# Town of Franklin

## Planning Board

**DATE:** August 19, 2020  
**TO:** Franklin Planning Board  
**FROM:** Department of Planning and Community Development  
**RE:** 5 Fisher Street and 29 Hayward St  
Site Plan Modification

**DATE:** August 4, 2020  
**TO:** Franklin Planning Board  
**FROM:** Department of Planning and Community Development  
**RE:** 160 Grove Street  
Special Permit & Site Plan  
Endorsement

DRAWING No. **H1**

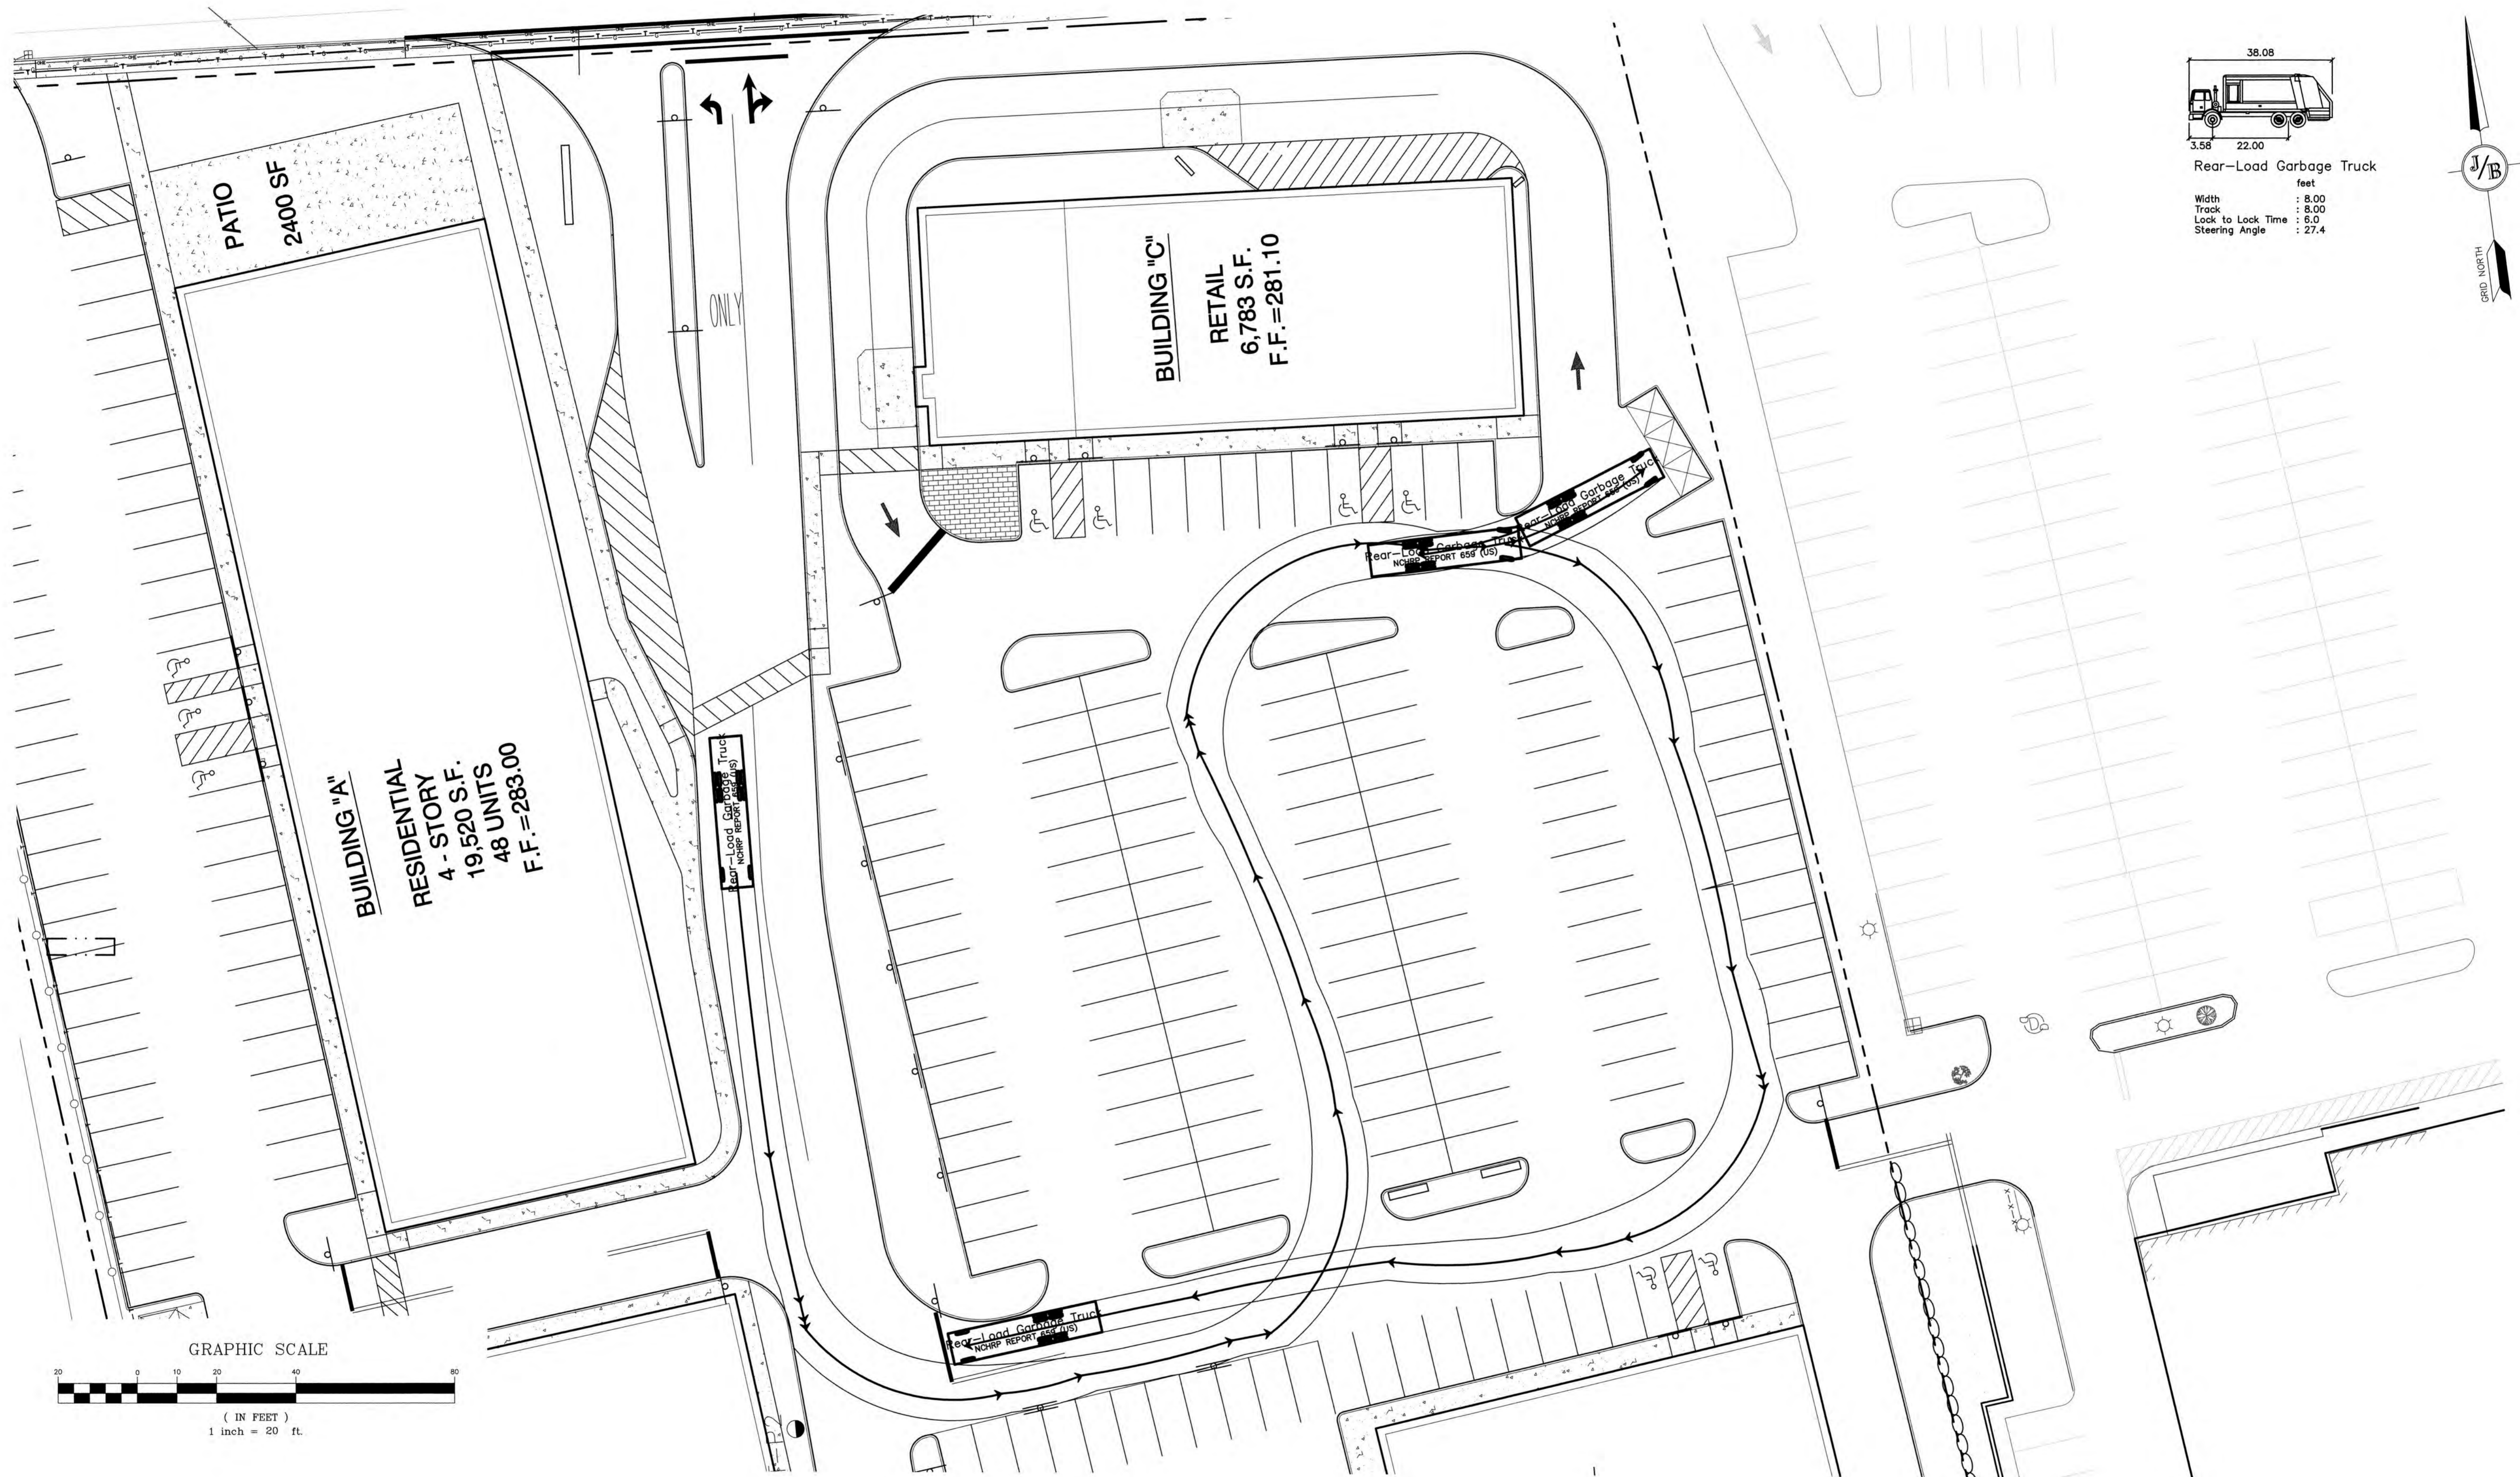
- S4. Provide sight line information, including intersection sight distance, at the proposed driveway egress (§185-31.C.(3)(t)). *JBE: A site distance plan has been included with the submission documents. See Sheet H1. BETA2: Information provided. Adequacy of sight distance will be evaluated as part of traffic review to be provided under separate cover.*

**RESPONSE: A site distance plan has been included with the submission documents. See Sheet H1.**

| Plan Name:       | <b>TRUCK TURNING PLAN #1</b>   |

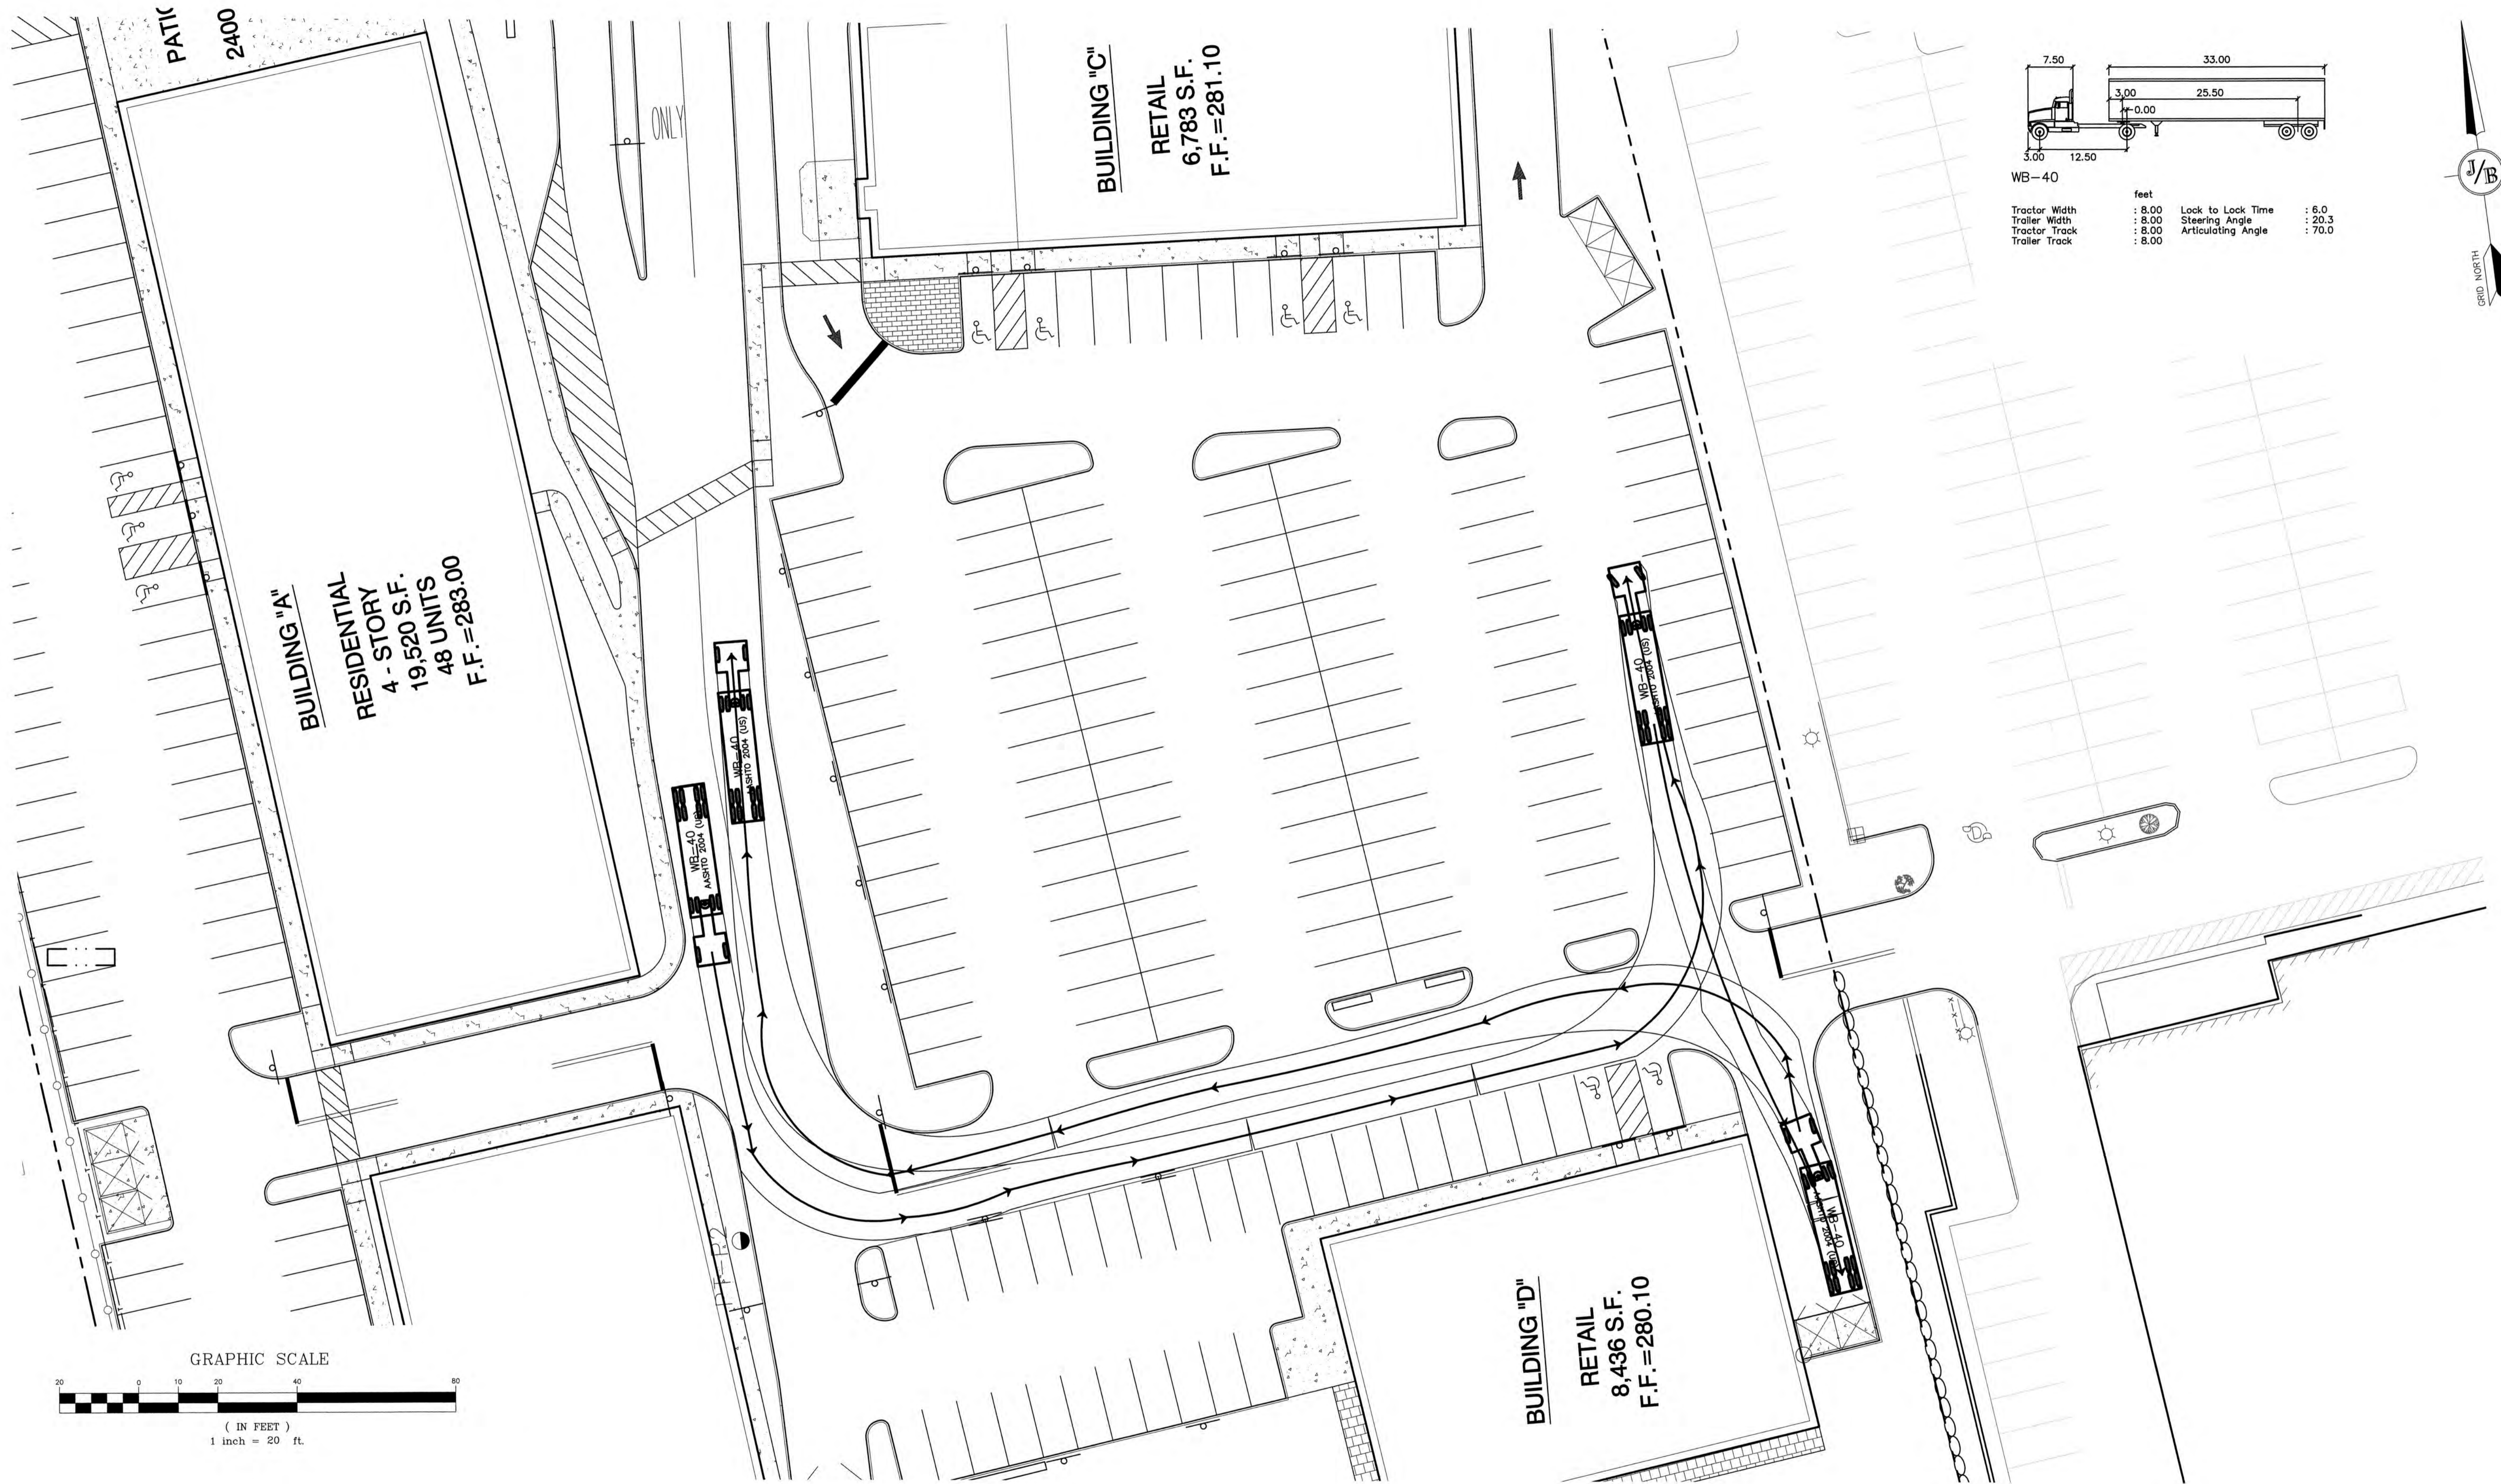
- P3. Confirm that a waste collection vehicle can adequately access the most northerly restaurant-use dumpster. *JBE: A waste collection vehicle can adequately access the most northerly restaurant-use dumpster. A truck turning plan (Sheet T1) has been included with our resubmission package.* **BETA2: A turning movement plan has been provided and shows access to the dumpster area in general but not the most northerly dumpster. Unless the dumpsters are intended to the roll out type it does not appear the truck can access it.** *JBE2: Truck Turning Plan #3 has been included with this response packing depicting these turning movements.* **BETA3: Following discussion with the design engineer, minor adjustments are being made to the dumpster area, which will allow adequate access to the dumpsters and will be incorporated into the final plan set – issue resolved.**

**RESPONSE: A waste collection vehicle can adequately access the most northerly restaurant-use dumpster. A truck turning plan (Sheet T1) has been included with our resubmission package.**

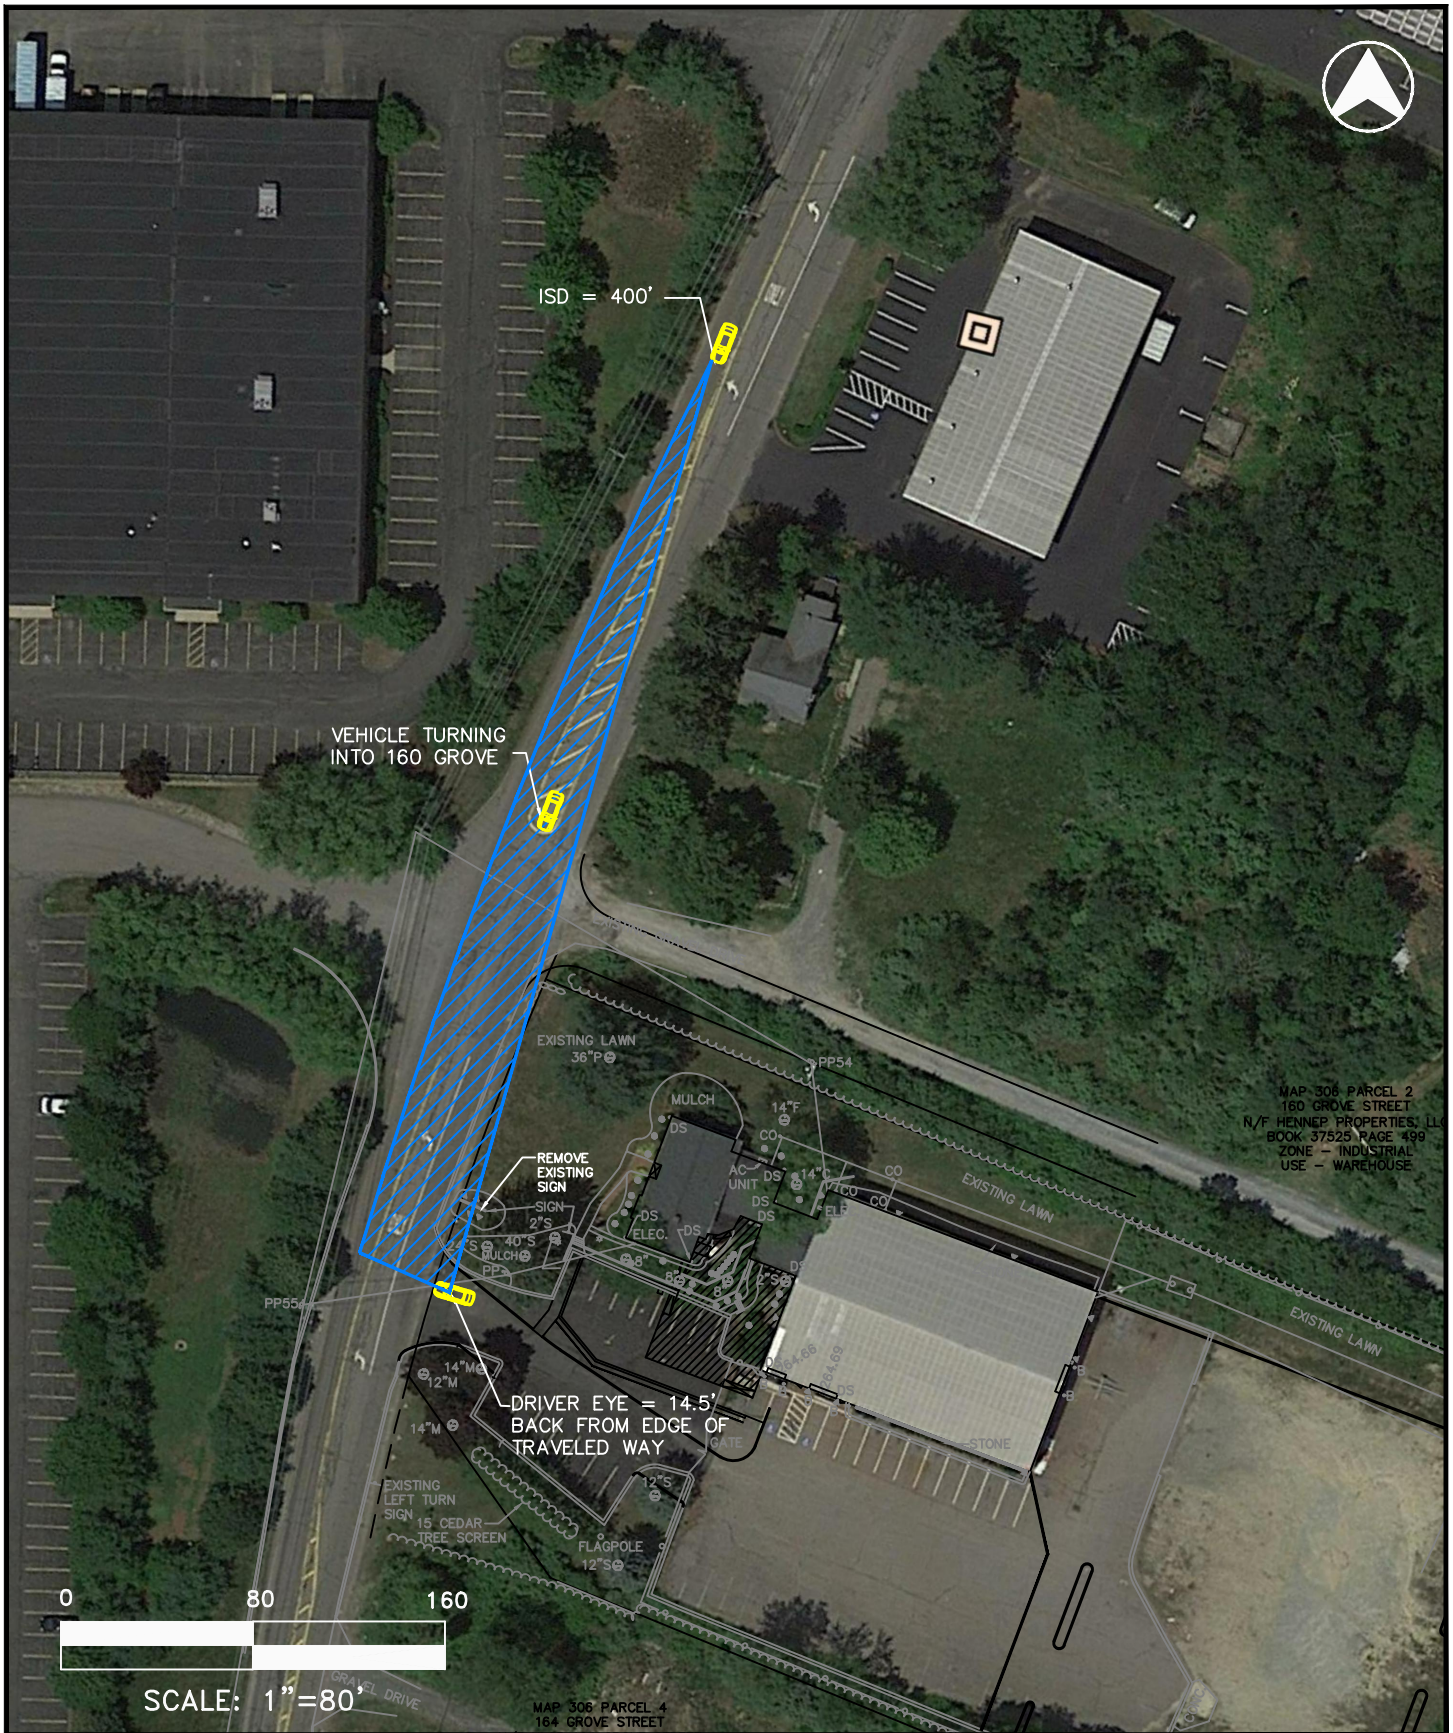
T8. As noted in the TIS, a southbound exclusive left-turn lane is proposed as part of the 160 Grove Street development. With this in mind verify that the sight distances approaching and exiting the driveway would continue to be adequate, especially during the AM peak period when 160 Grove Street employees would be entering 160 Grove Street and close to 200 vehicles would be entering and exiting the site driveway. TT: *As shown on the attached Figure 1, a vehicle waiting to turn left into 160 Grove Street does fall within the sight triangle and could block the sight line for a driver looking right from the site to a vehicle traveling southbound along Grove Street past the proposed left-turn lane 160 Grove site driveway for a short distance (approximately 70 feet). However, there are only 42 vehicles expected to turn left into 160 Grove Street during the morning peak hour. Under the proposed 2027 Build conditions, the capacity analysis indicates that the southbound left-turn lane at 160 Grove Street is expected to be queue free 95 percent of the time during the weekday morning peak hour, with a 95<sup>th</sup> percentile queue length of 0.2 vehicles. Additionally, the number of vehicles exiting the site during the morning peak hour is now expected to be significantly reduced based on NETA’s currently proposed operation of the facility.* BETA 2: Information provided – issue resolved.

**Response:** As shown on the attached Figure 1, a vehicle waiting to turn left into 160 Grove Street does fall within the sight triangle and could block the sight line for a driver looking right from the site to a vehicle traveling southbound along Grove Street past the proposed left-turn lane 160 Grove site driveway for a short distance (approximately 70 feet). However, there are only 42 vehicles expected to turn left into 160 Grove Street during the morning peak hour. Under the proposed 2027 Build conditions, the capacity analysis indicates that the southbound left-turn lane at 160 Grove Street is expected to be queue free 95 percent of the time during the weekday morning peak hour, with a 95<sup>th</sup> percentile queue length of 0.2 vehicles. Additionally, the number of vehicles exiting the site during the morning peak hour is now expected to be significantly reduced based on NETA's currently proposed operation of the facility.
